**MEMO**

**Ref.** 2AM-BRP1831

**Subject** 2AM-BRP1831 Amendment No. 1 Design Report Umwelt Saline Water Pond Dam – Responses to Review Comments

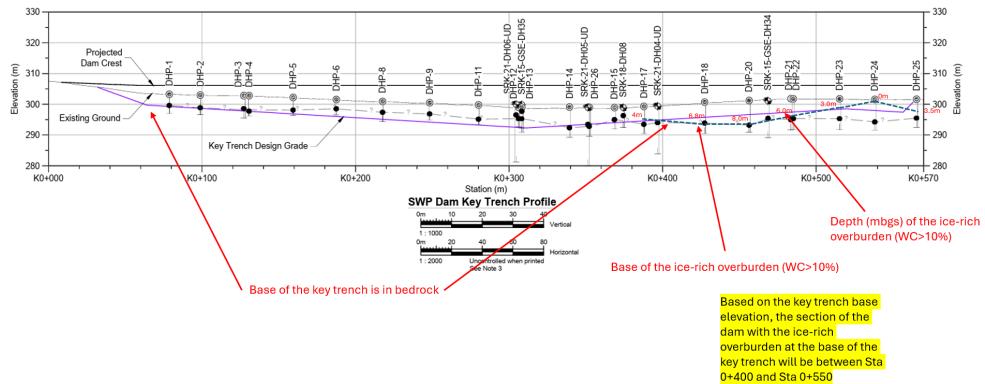
Below provides a marked-up screenshot to show additional comments, specific to the SWP Phase 1 dam, that were considered in the current key trench designs.
